**S-52 Presentation Library Draft Edition 4.0.3**
Response on Alvaro's comments - from Hannu
Hi Alvaro, - I looked your comment form about cases which may need update on ECDIS Chart 1 screen plots;

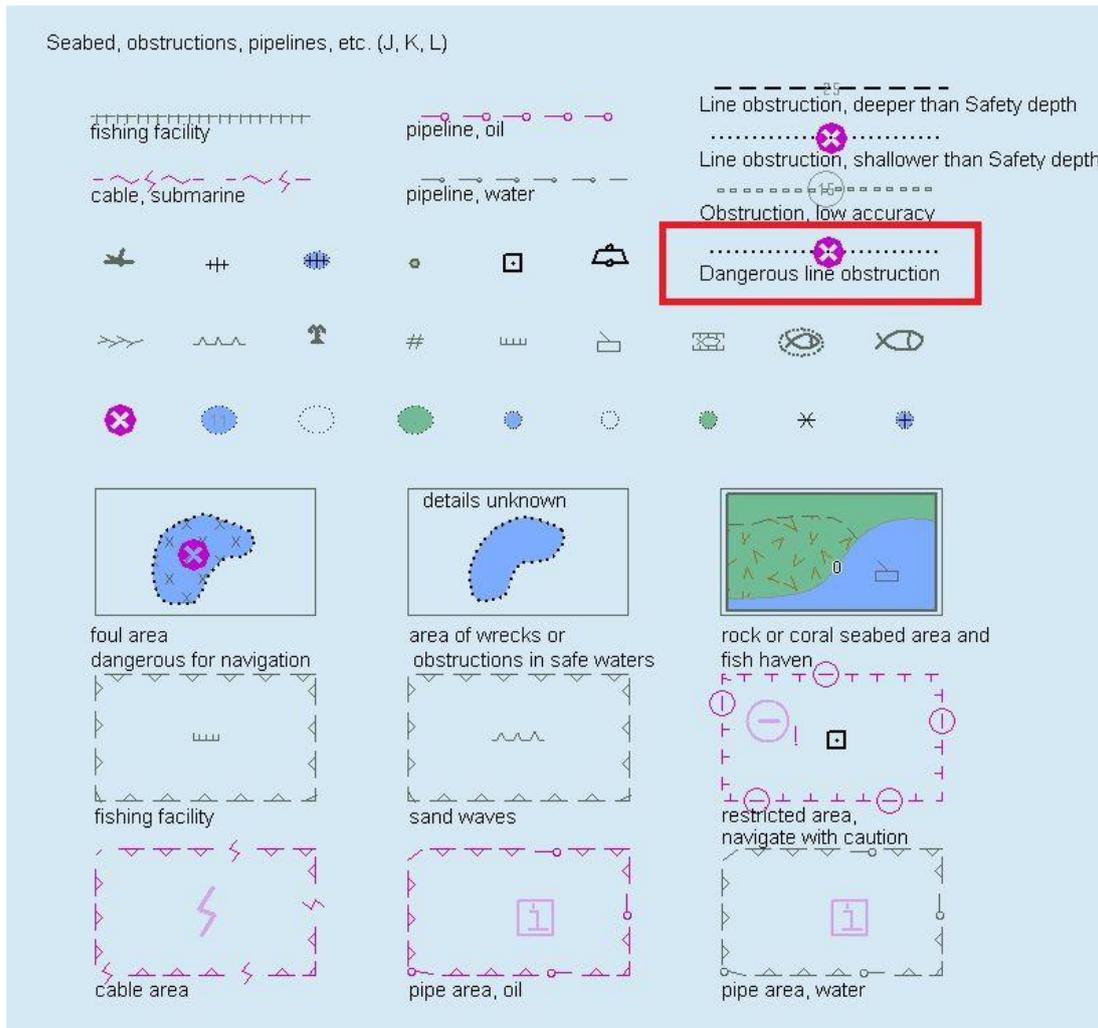
|	AU	16.2		te	'Port features (F)'. Symbol OBSTRN11 does not display as expected, Drawing instructions may be corrupted in the ECDIS used to get the screenshot for the S-52 plot.	Amend symbol display and replace plot.	
					The symbol displays correctly in the ECDIS used at the AHO.

Thank you for good catch. The drawing of symbol OBSTRN11 can be fixed for the plot, see fixed plot below:
